REMARKS

ANNOTATED MARKED-UP DRAWING

Serial No: 10/675,378

For: ELECTRICAL POWER CONTROL SYSTEM

FIG 1

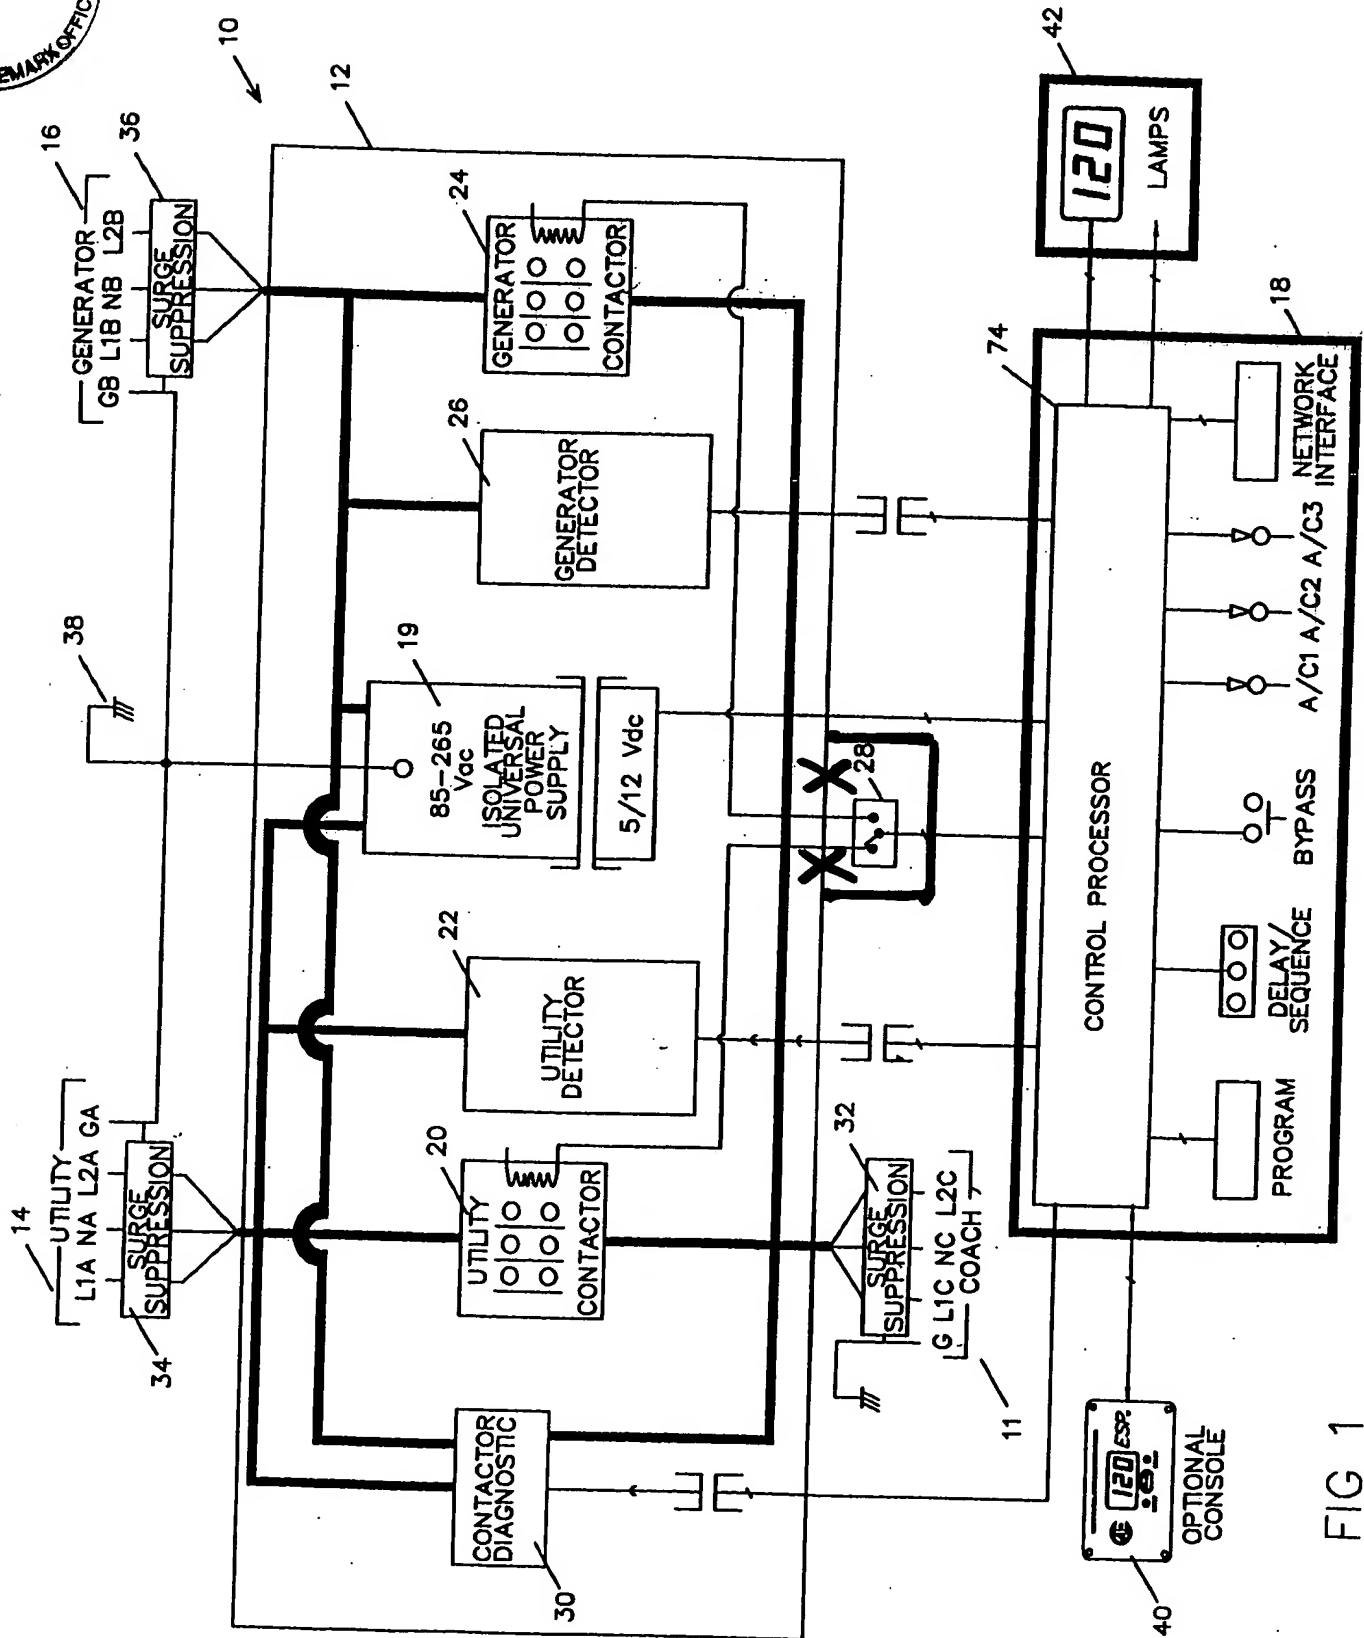
The outstanding Examiner's Amendment of August 17, 2006, indicates a corrected drawing sheet of Fig. 1 is required in reply to the Office Action.

Fig. 1 switch (28) was not within, and therefore not included in, power supply stage (12).

The drawing has been amended to include Fig. 1 switch (28) within, and therefore included in, power supply stage (12) in response to the Examiner's comments and is now believed to be in condition for allowance.
